PRELIMINARY ENGINEERING
IMX-080-3(315)128--02-77
POLK COUNTY

PLANS OF PROPOSED IMPROVEMENT ON THE
PRIMARY ROAD SYSTEM
POLK COUNTY
PRELIMINARY ENGINEERING

I-35/80 from IA 141 in Urbandale to E of I-35/80/235
 Northeast Mixmaster System Interchange (NEMM)

FIELD EXAM CHECKLIST

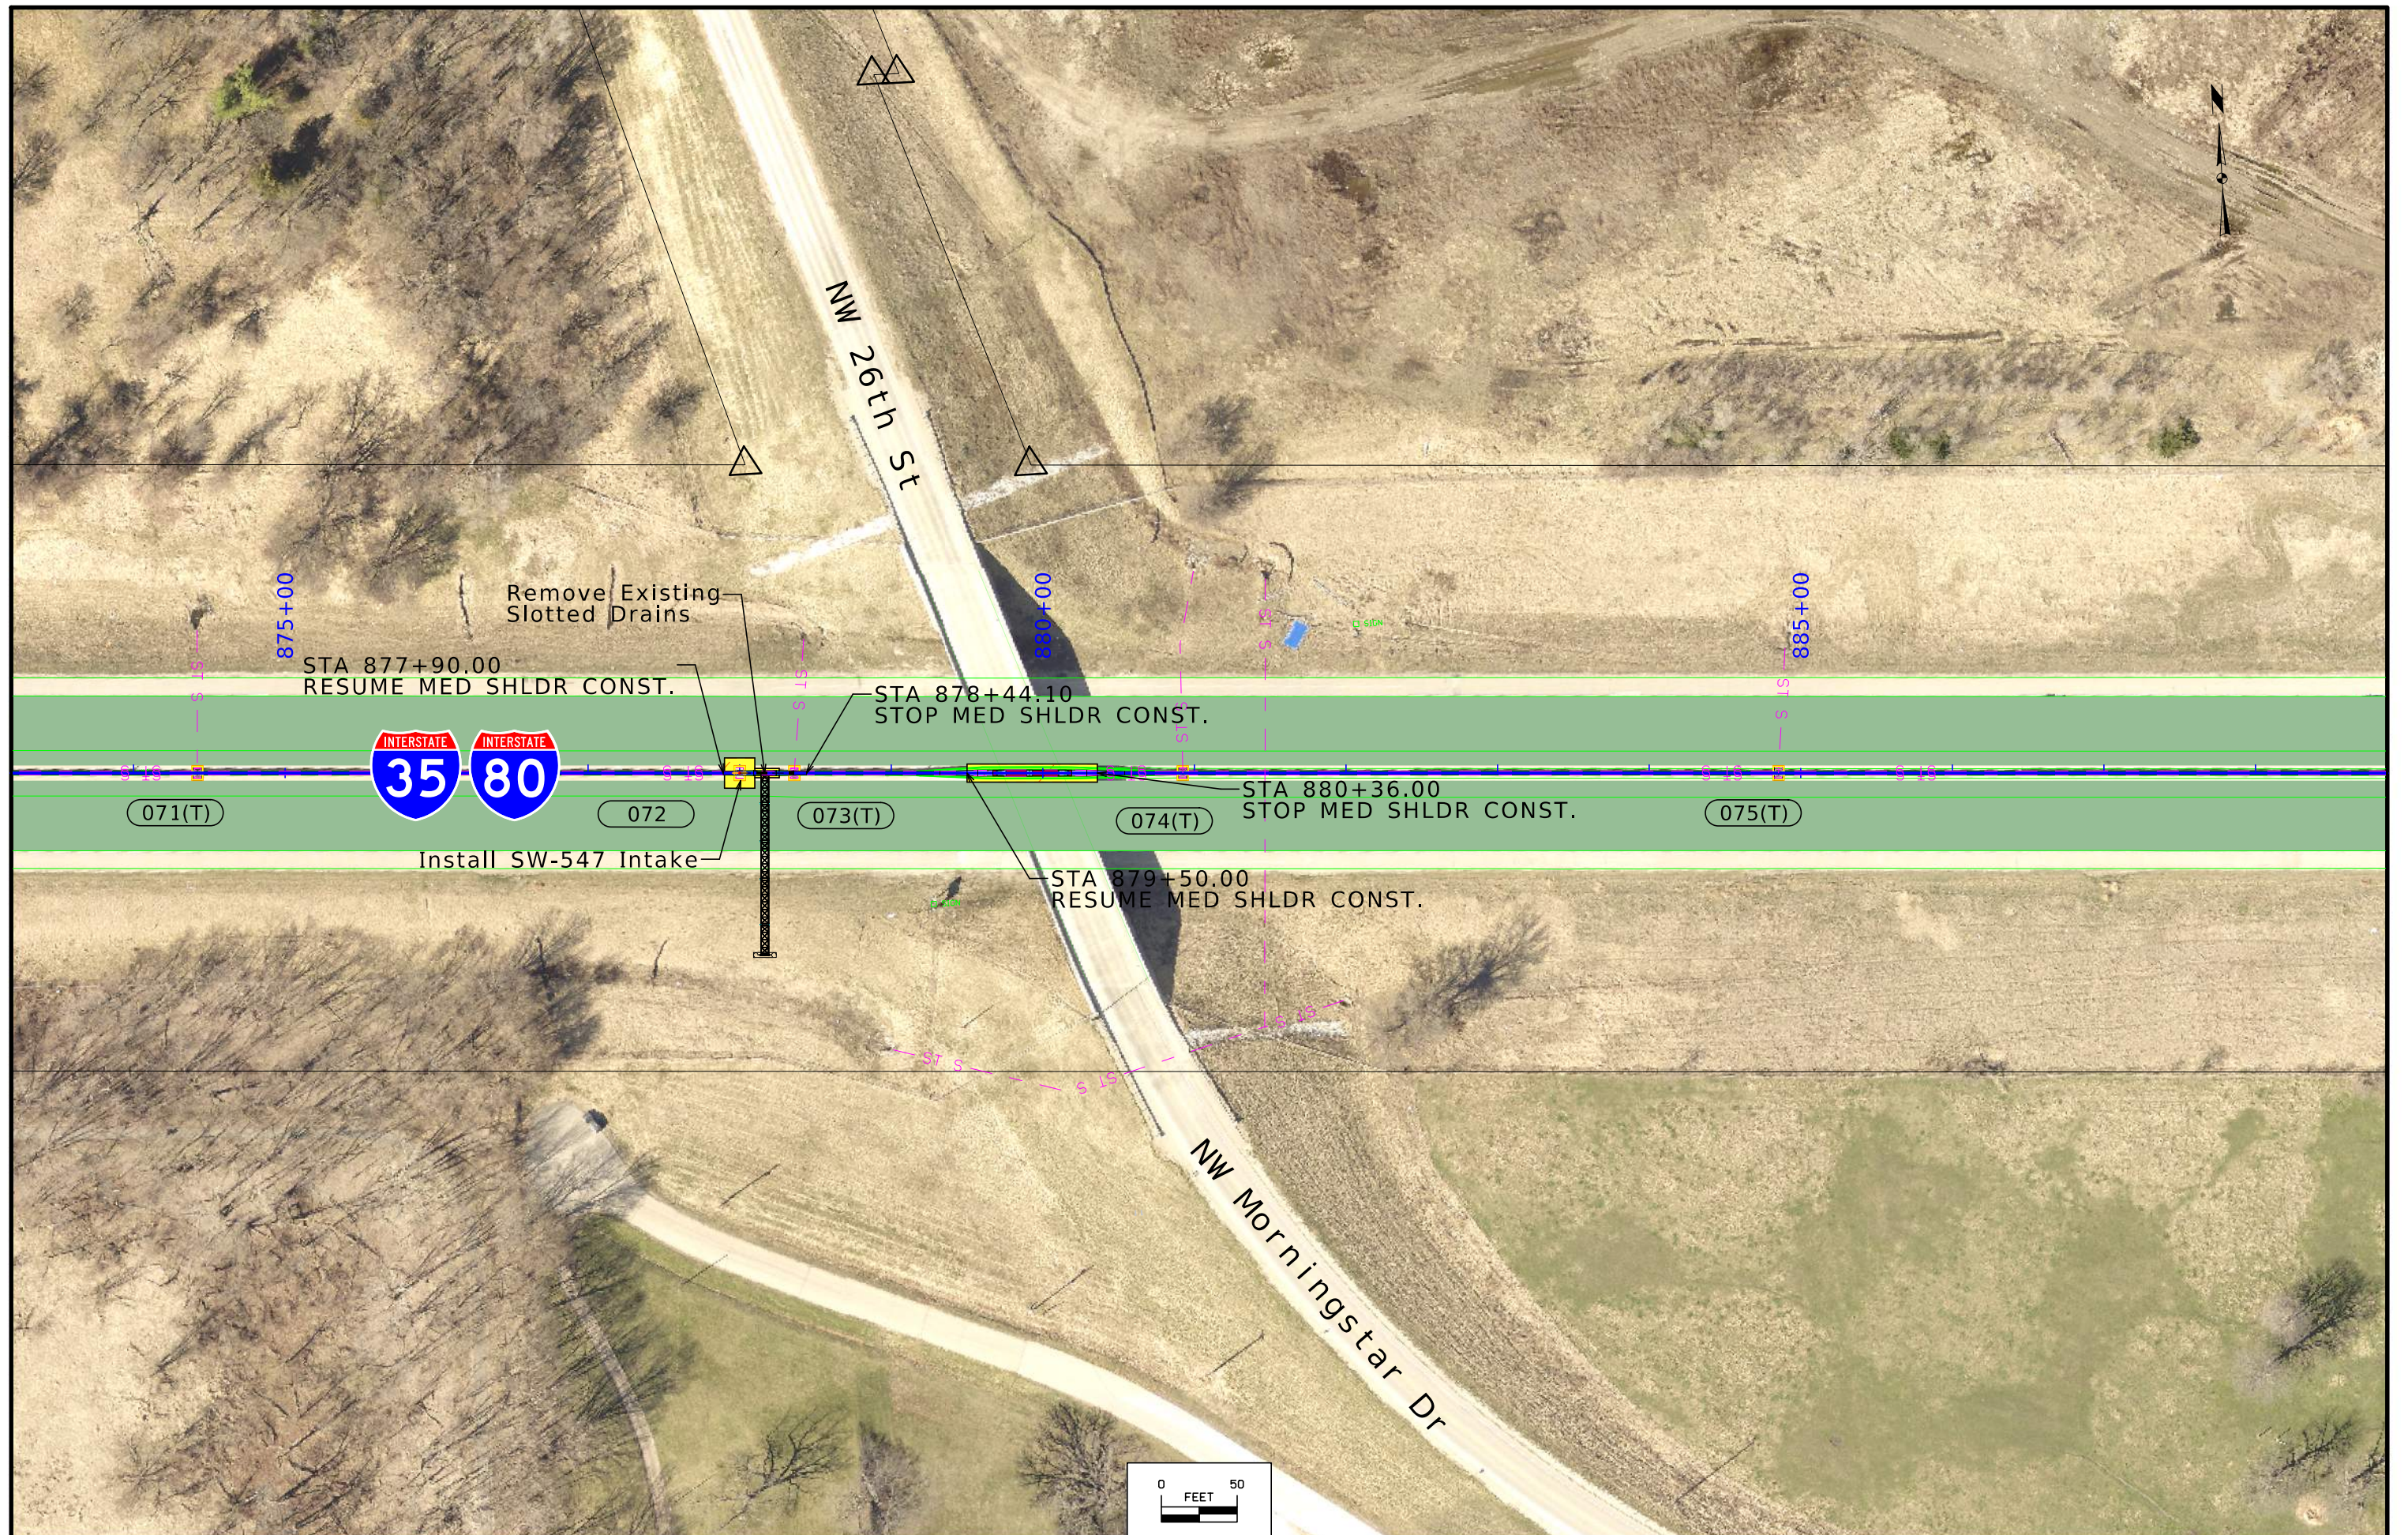
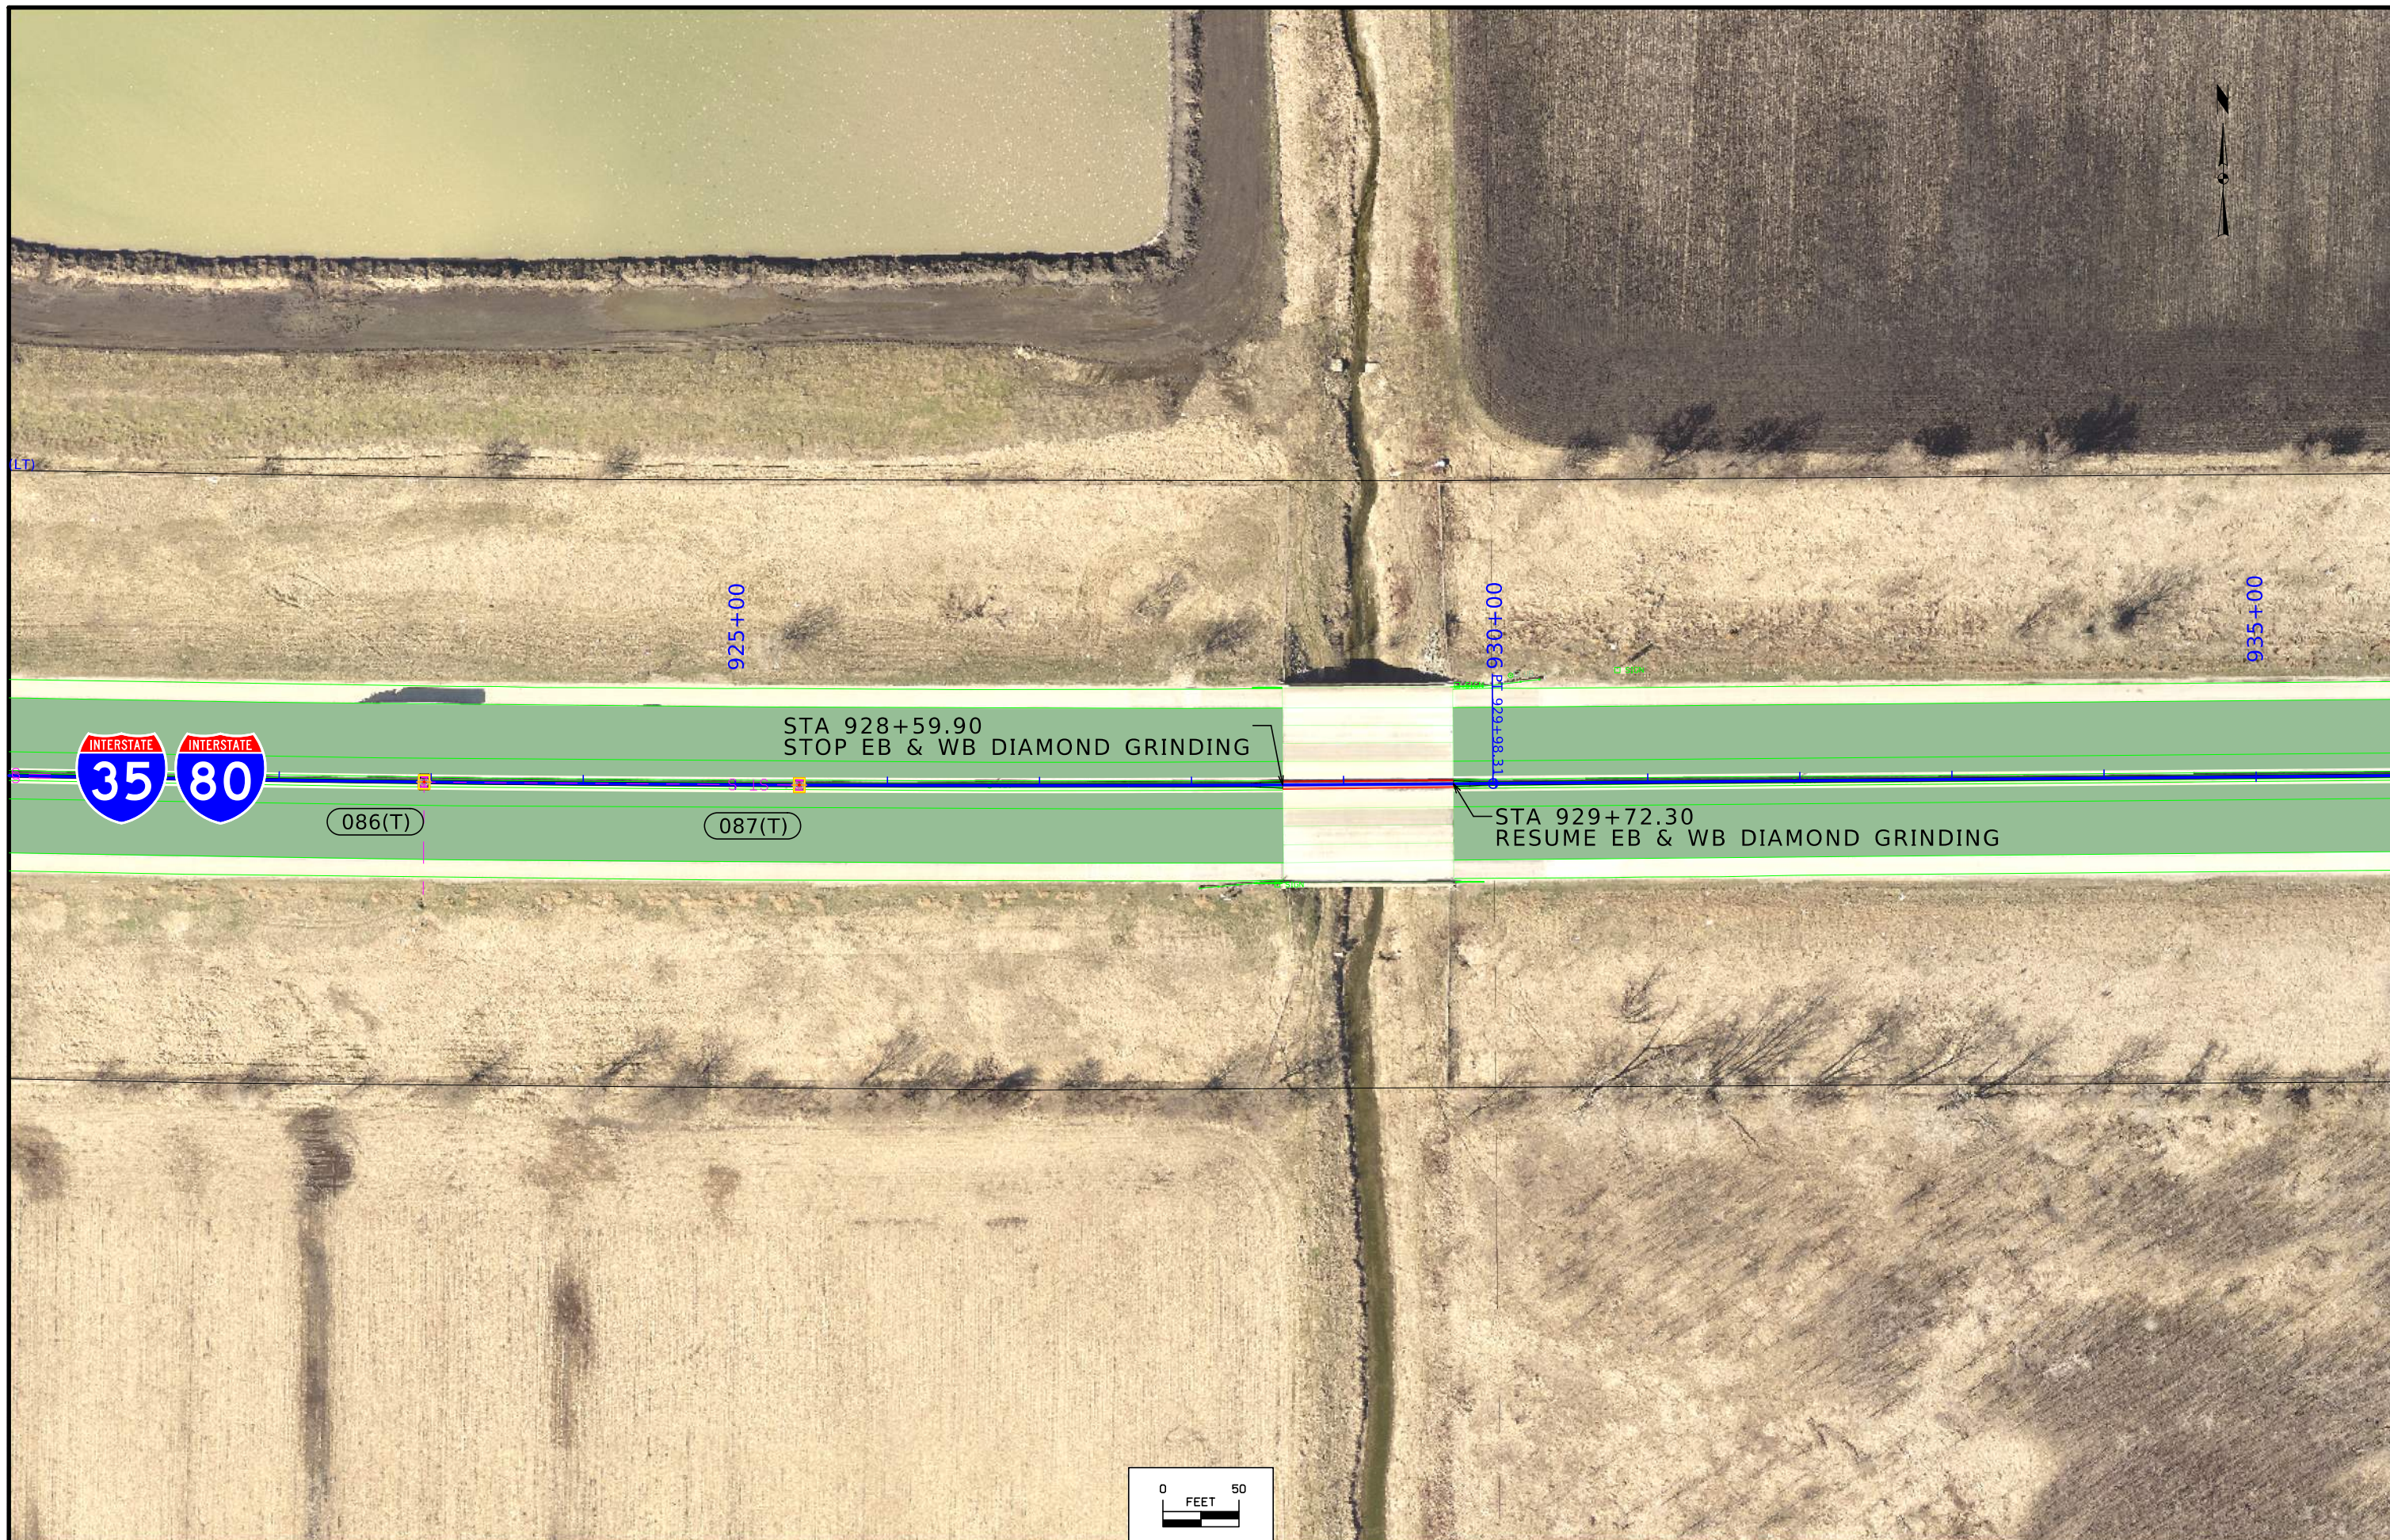
Remove Existing Slotted Drains

Install SW-547 Intake

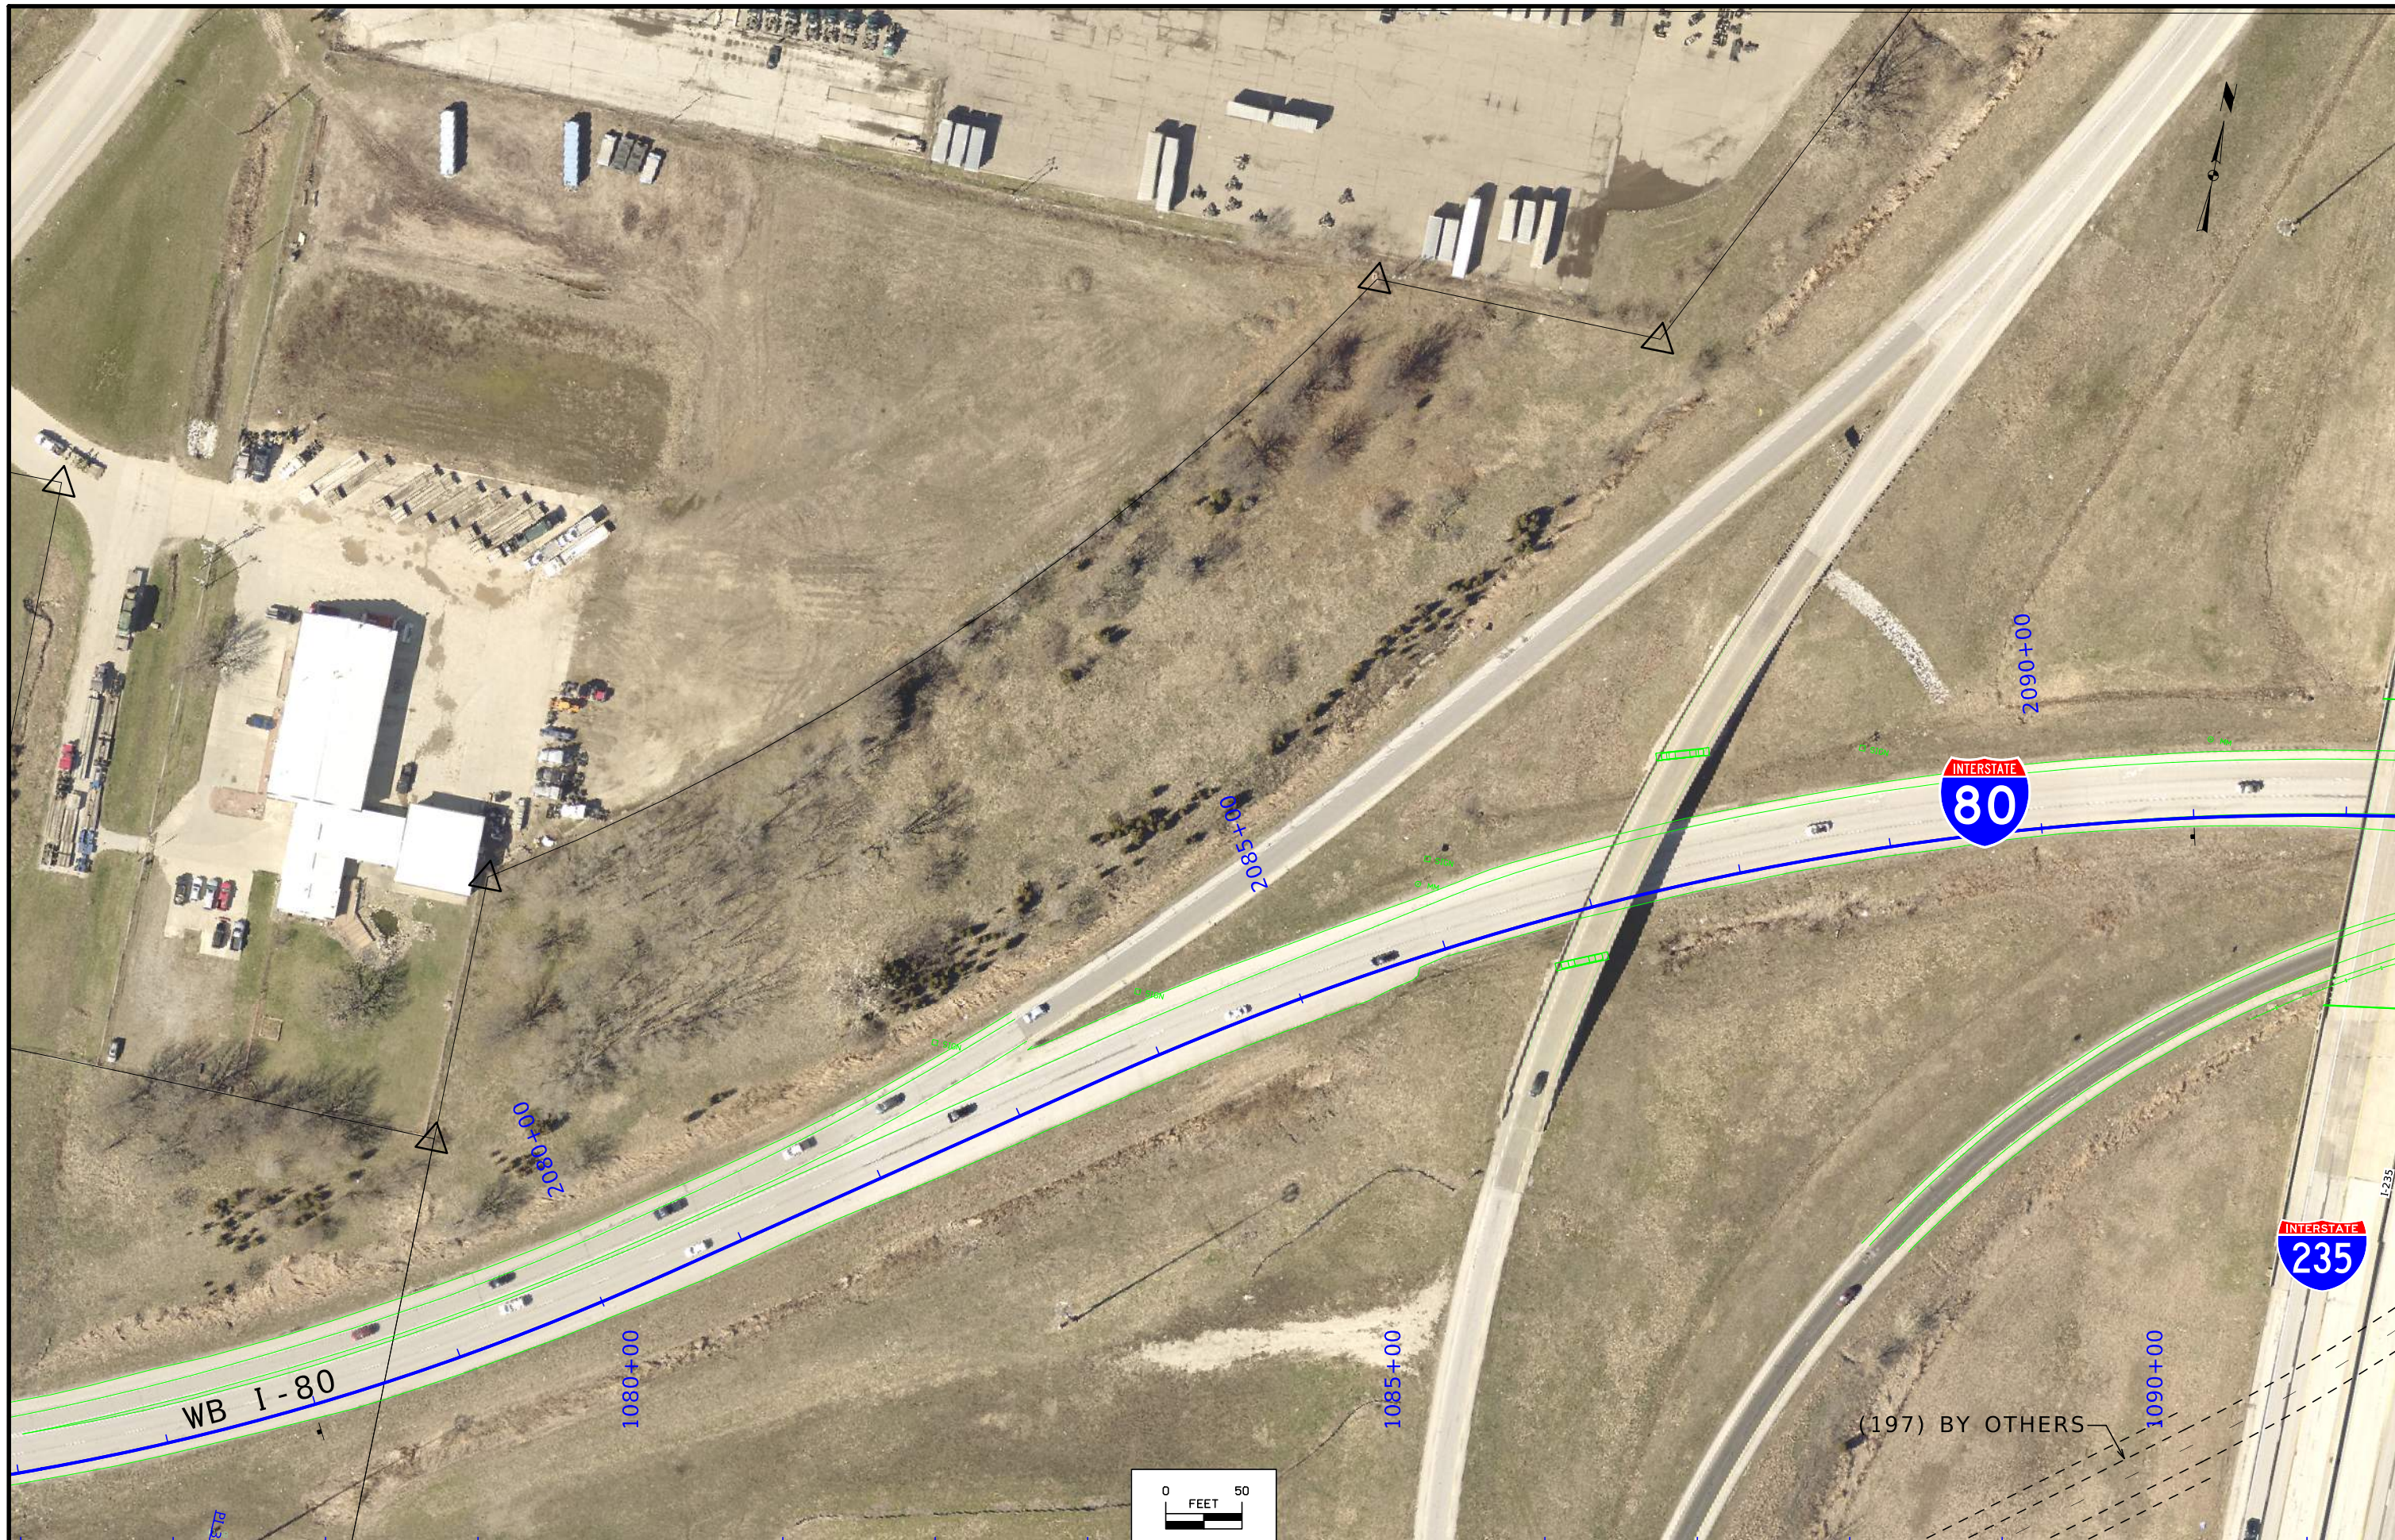
EB shoulder widening assumes the mainline lane cross-slope break created by removal of the left exit is corrected with NEMM Stage 3.
